Hi-Fi Products
Service Bulletin

Model: D-311

No. 313

Subject: Discs Do Not Play.

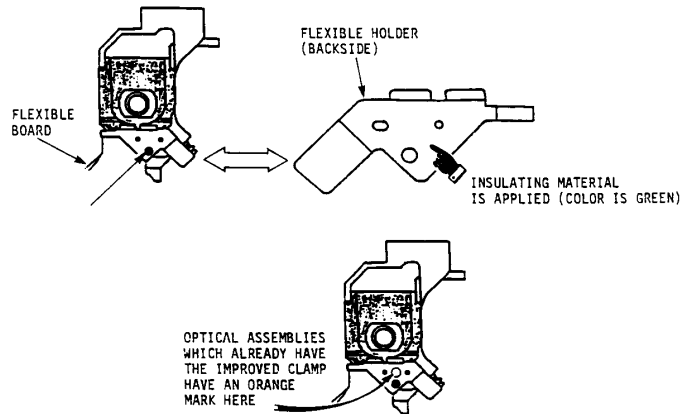
The PD signal lead of the flex cable shorts to the clamp which secures the flex cable to the optical assembly. This prevents the disc from playing.

Solution: Replace the clamp with an improved type.

REF	DESCRIPTION	PART NUMBER
-	FLEX CABLE HOLDER	2-625-775-03

Note: Some optical assemblies have been manufactured with the improved clamp. These assemblies can be identified by an orange mark on the clamp.
